**Agnico Eagle Mines Limited – Meadowbank Division**

**2AM-MEA1526**

**PROPOSED MODIFICATION  
NWB IN-PIT TAILINGS DISPOSAL  
COMMENT RESPONSES**

**August 17, 2018**

**Figure 2.1 – Golder and SNC models overlay**

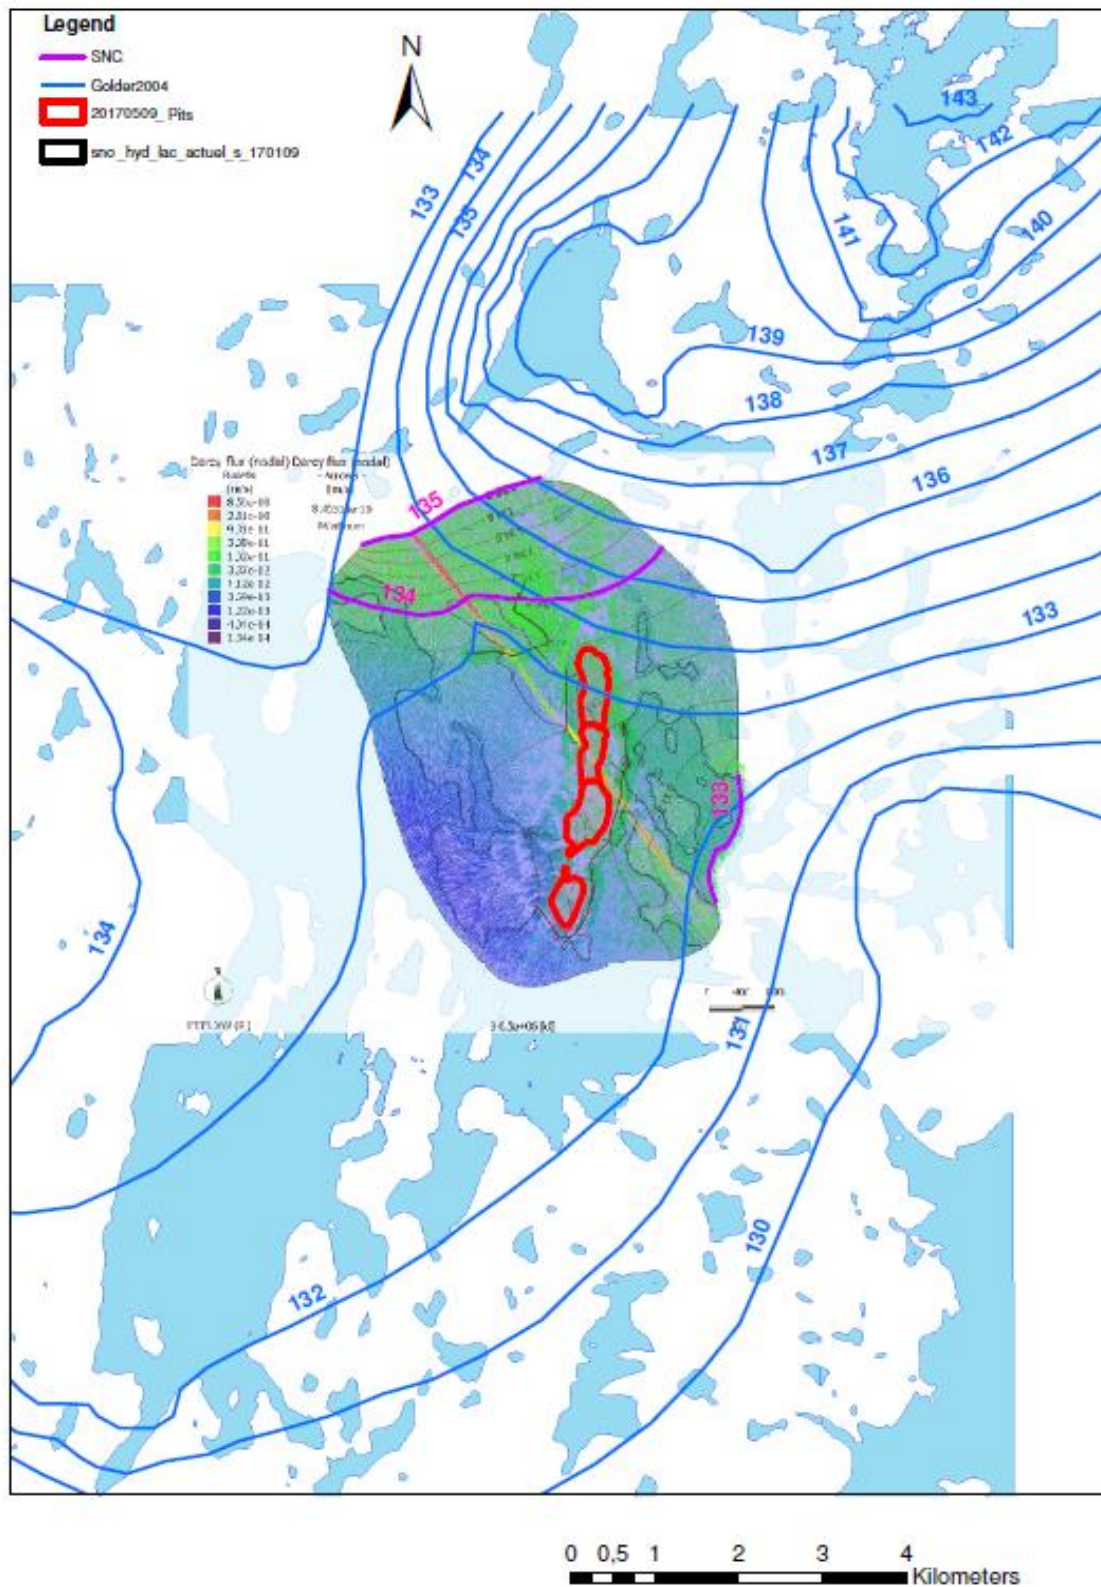
Agnico Eagle agrees to provide further information to respond to NRCAN2ii) recommendation. For clarification, Agnico Eagle believes the recommendation NRCAN-02ii) is the same as NRCAN-01. As per Agnico Eagle response to NRCAN-01, the Version 1 (SNC, 2017) and 2 (SNC, 2018a) hydrogeological modelling provided to NWB is sufficient to support the modification process. Agnico Eagle disagrees with NRCAN2i) recommendation as for contaminant transport simulation, using a larger model and elements could lead to numerical dispersion and to numerical errors. These results and any future annual monitoring and modelling updates will be provided to NWB in annual reporting and updated management plans according to the 2AM MEA1526.

The Version 3 hydrogeological model (sensitivity analysis of Version 2) will assign the sub-permafrost boundary conditions of the Golder model. The following map provides NIRB the overlay of the Golder (2004, 2005) regional model and the SNC Version 1 and 2 hydrogeological models.

As presented on Figure 2.1, Versions 1 and 2 of the hydrogeological models and the Golder (2004,2005) regional model are showing similar hydraulic heads at the boundary conditions used for Versions 1 and 2 hydrogeological models.
